MEMORANDUM

SUBJECT: Mandatory Referral No. 07204-MCPS-1: Walter Johnson High School
Modernization – 6400 Rock Spring Drive, R-90 Zone, North Bethesda
Master Plan

SUBJECT: Mandatory Referral No. 07204-MCPS-1
Walter Johnson High School Modernization
North Bethesda Policy Area

Proposed Site Plan

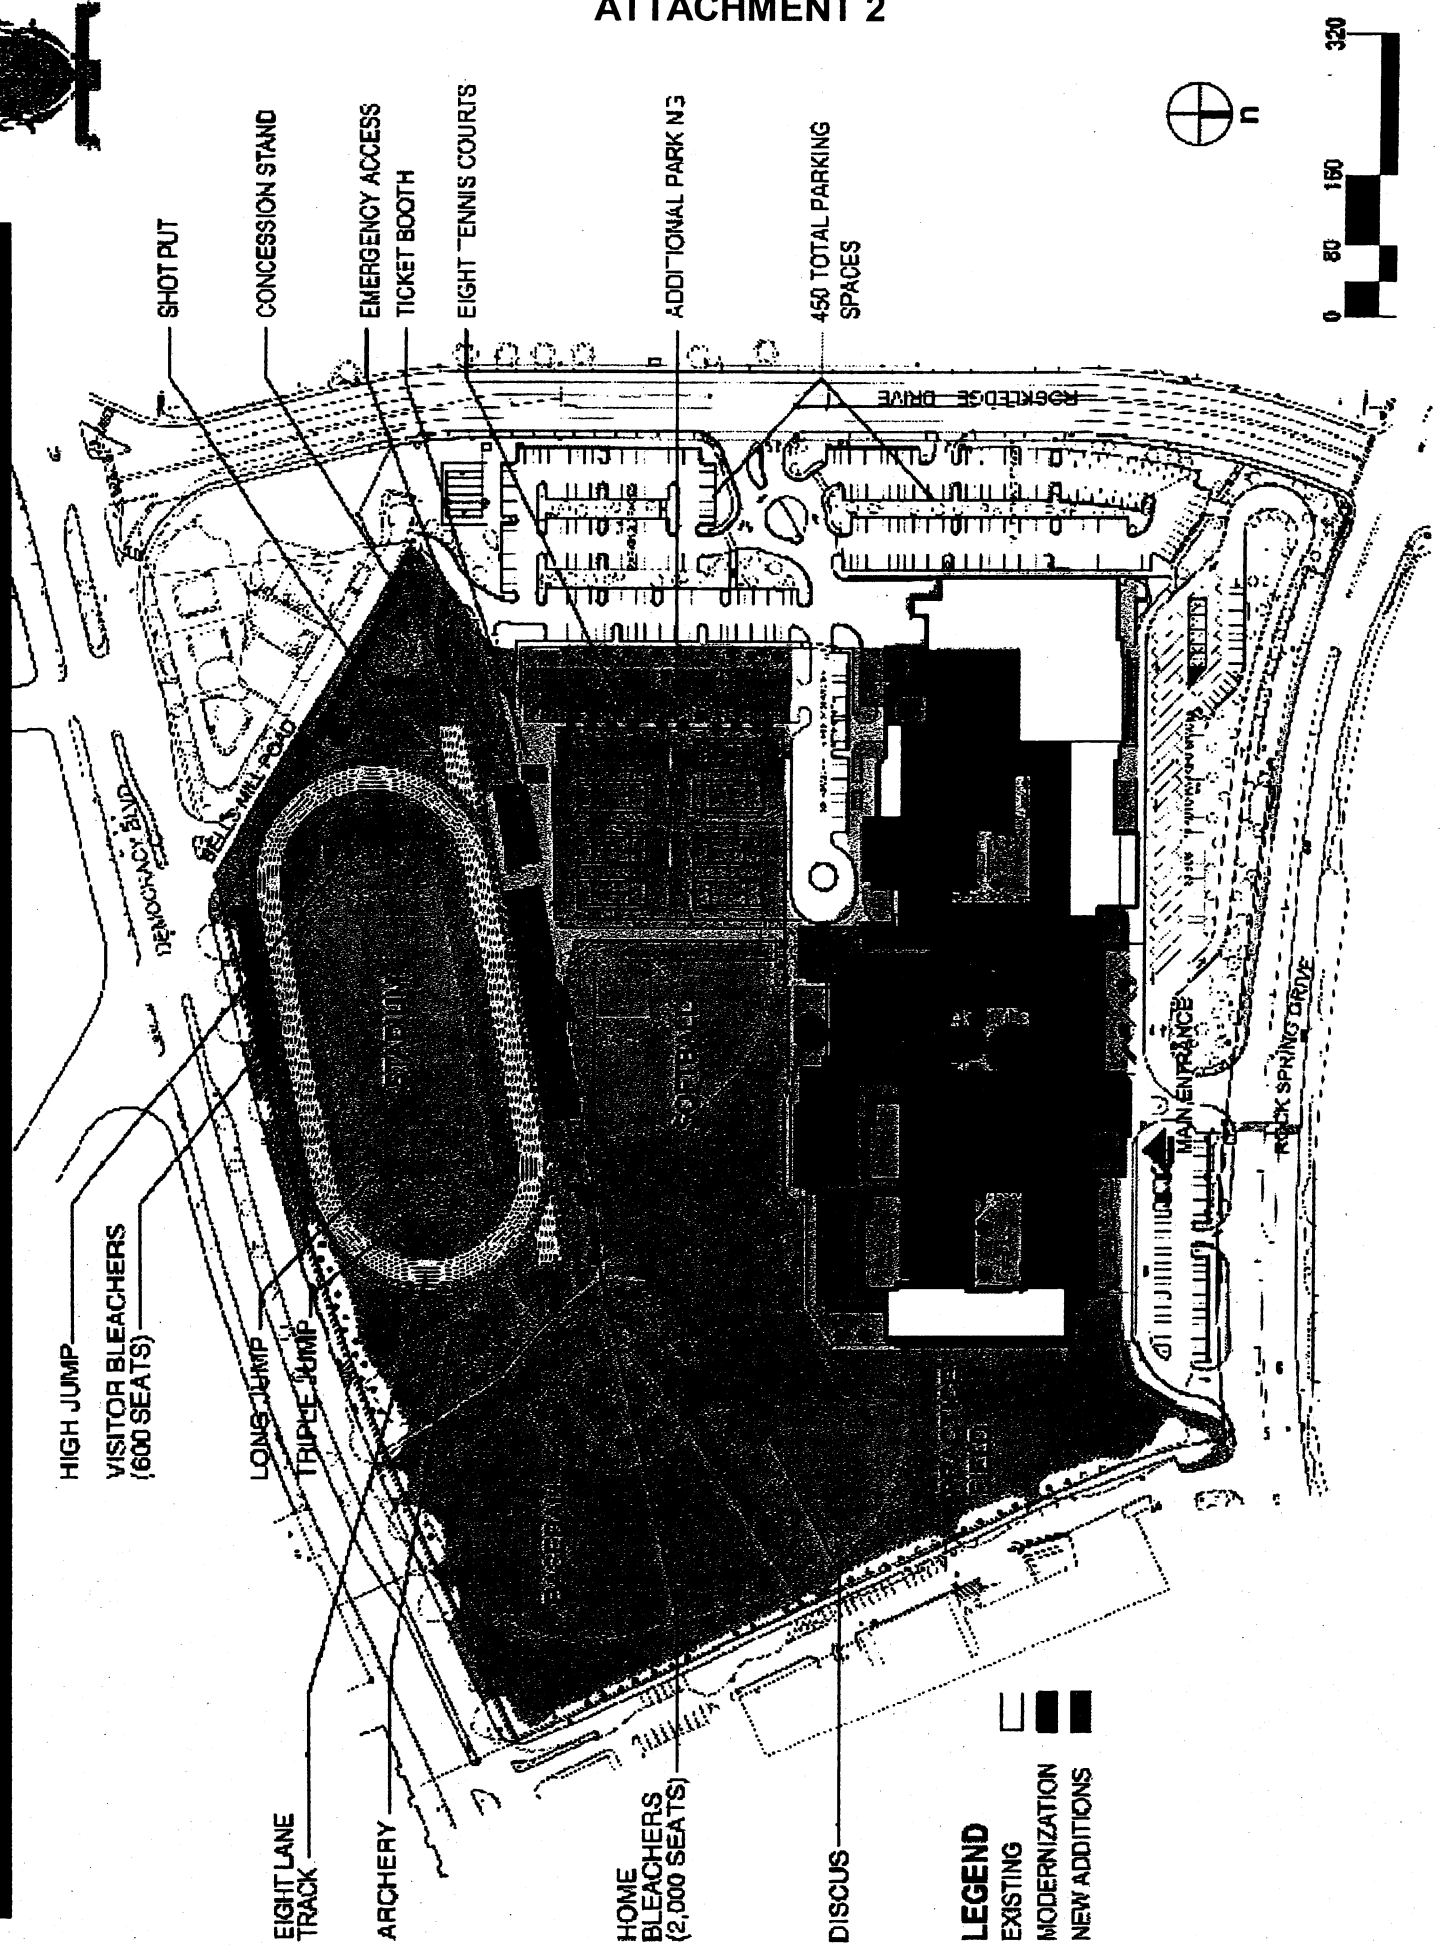
The submitted lighting plan illustrates that wall mounted lights on the school will not impact adjacent rights-of-way. Existing lights for the athletic fields will be retained. New landscaping is proposed for the eastern portion of the school. Staff recommends that the applicant provide additional landscaping along Rock Spring Drive to screen existing surface parking.

Pedestrian crosswalks are needed at the handicapped ramps across the driveways along Rock Spring Drive and Rockledge Drive as recommended in Finding No. 3. The main pedestrian lead-in walkway from Rock Spring Drive is on the eastern side of the driveway into the school bus drop-off and pick-up area. The short segment of the lead-in sidewalk on the western side of this driveway between the handicap ramp and the sidewalk end should be removed to discourage pedestrians from crossing the school bus driveway at a second point as recommended in Finding No. 4. The southernmost portion of the student and staff parking lot has a combination of sidewalks and crosswalks that do not provide a continuous connection to either the school building or other destinations such as the sports facilities. The designated pedestrian paths in this parking area should be revised to more clearly communicate a continuous connection between the parking area and pedestrian destinations on the school property as recommended in Finding No. 5.
